Below is the list of 13 variances required as listed in staff memo for zba hearing on 15 dec 2021. Revisions to the proposed design make 6 of the variances no longer required. The 6 variances that are no longer required are shown with a strikethrough.

V11 -
BUILDING WIDTH
 REQUIRES RELIEF

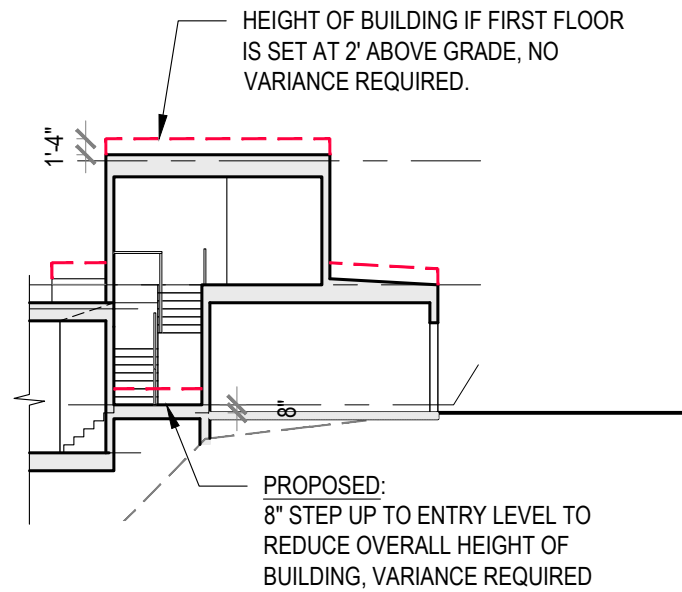
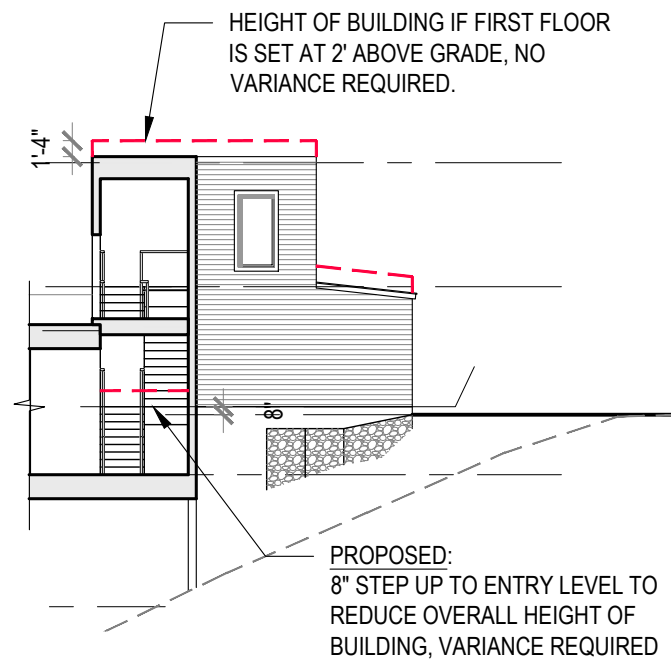
BUILDING WIDTH REQUIRES RELIEF, BECAUSE THE PROPOSAL PLACES THE UNITS BESIDE ONE ANOTHER RATHER THAN STACKING ONE OVER THE OTHER. THIS IS NECESSARY IN ORDER TO HAVE A LOWER TOP HEIGHT MADE POSSIBLE BY STEPPING THE BUILDING DOWN THE SLOPE.

V12 -
GROUND STORY
ELEVATION

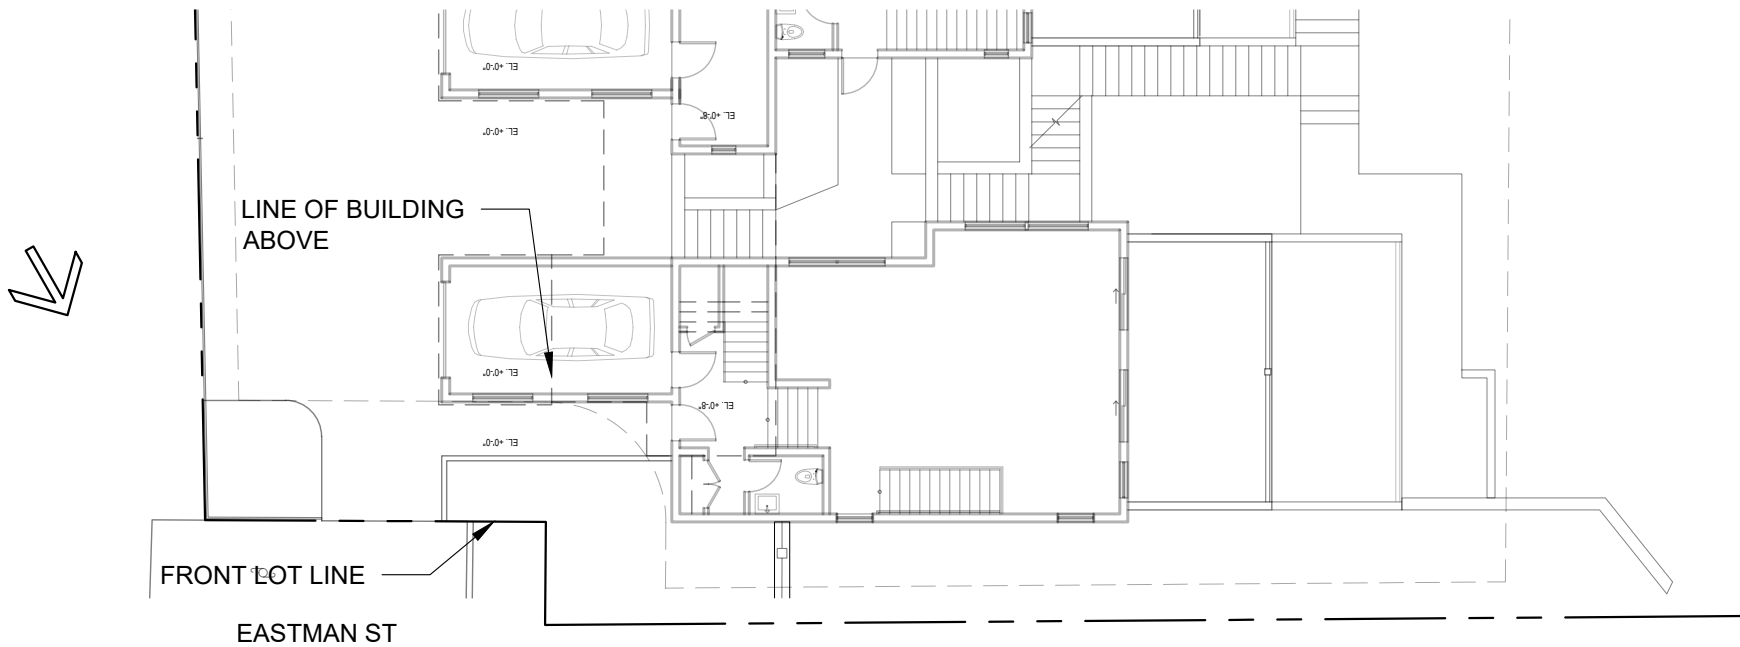
GROUND STORY ELEVATION
REQUIRES RELIEF, BECAUSE
PROPOSED DESIGN SEEKS TO
LOWER THE TOP HEIGHT OF THE
BUILDING.

REQUIRES RELIEF

V13 -
UPPER STORY
FENESTRATION

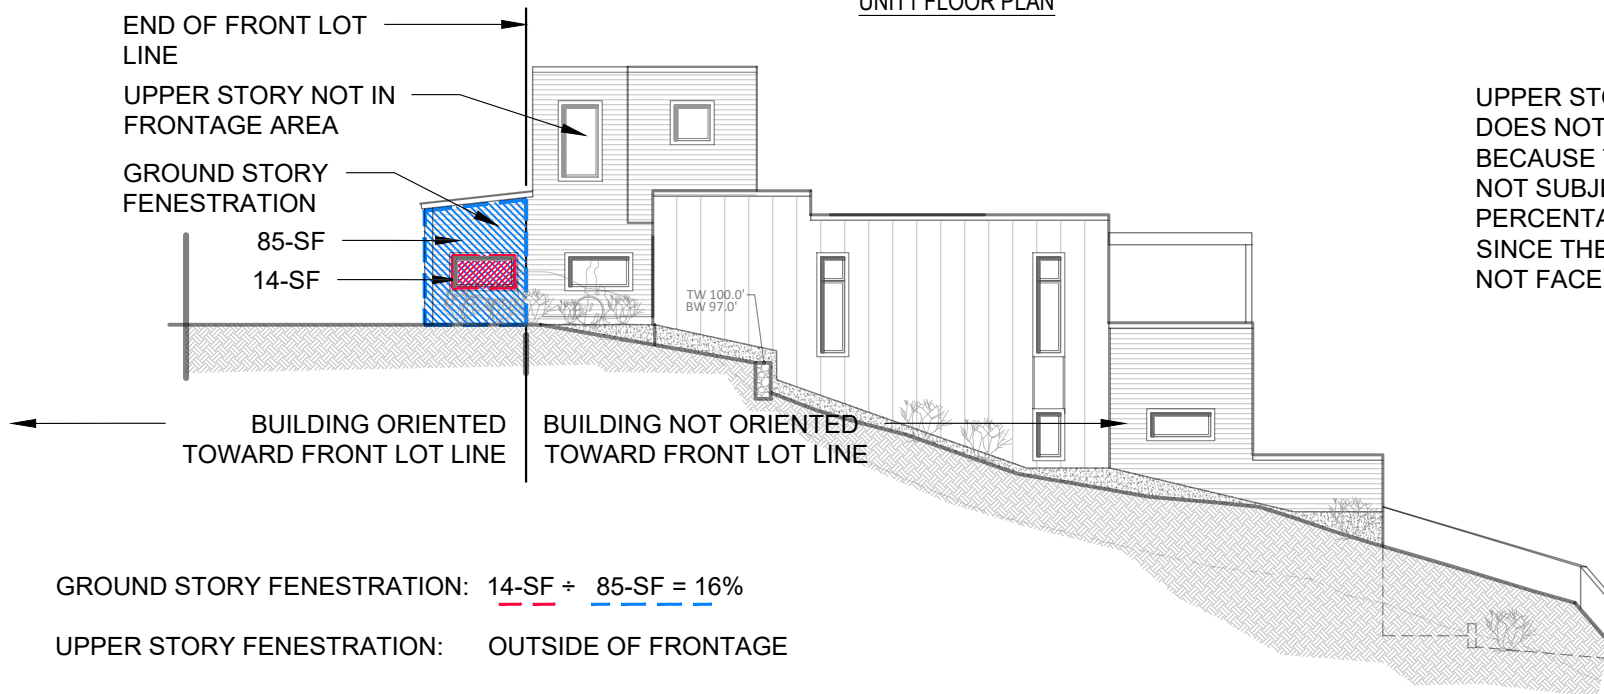
UPPER STORY FENESTRATION DOES NOT REQUIRE RELIEF, BECAUSE THE UPPER STORY IS NOT SUBJECT TO FENESTRATION PERCENTAGE REQUIREMENTS, SINCE THE UPPER STORY DOES NOT FACE A FRONT LOT LINE.

DOES NOT
REQUIRE RELIEF
